SERVICE BULLETIN – 01/MARCH 2004

SPR 80

NEW OPTICAL ICE LEVEL CONTROL BRACKET KIT

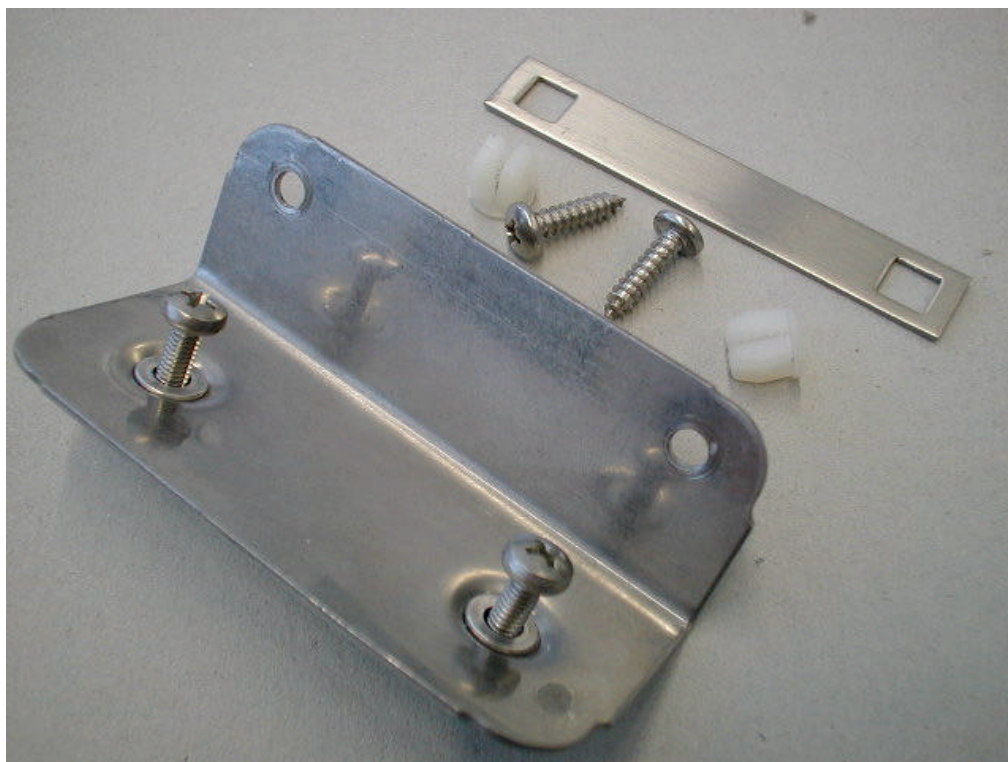
As written on the previous Service Bulletin 01/March 2004, the Optical Ice Level Control has been moved/relocated in a different place inside the storage bin so to increase the level of the stored ice by 5-6 kgs.

Now, a new RETROFIT KIT is available in order to modify, if need, the machines in the field.

The new Optical Ice Level Control Bracket Retrofit Kit is available under **Part Number 060616 00** and it consists of parts shown on the bottom photo.

The metal bracket must be secured to the upper front side of the spout opening of the storage bin as detailed on the following photos after have drilled three holes as per attached drawing.
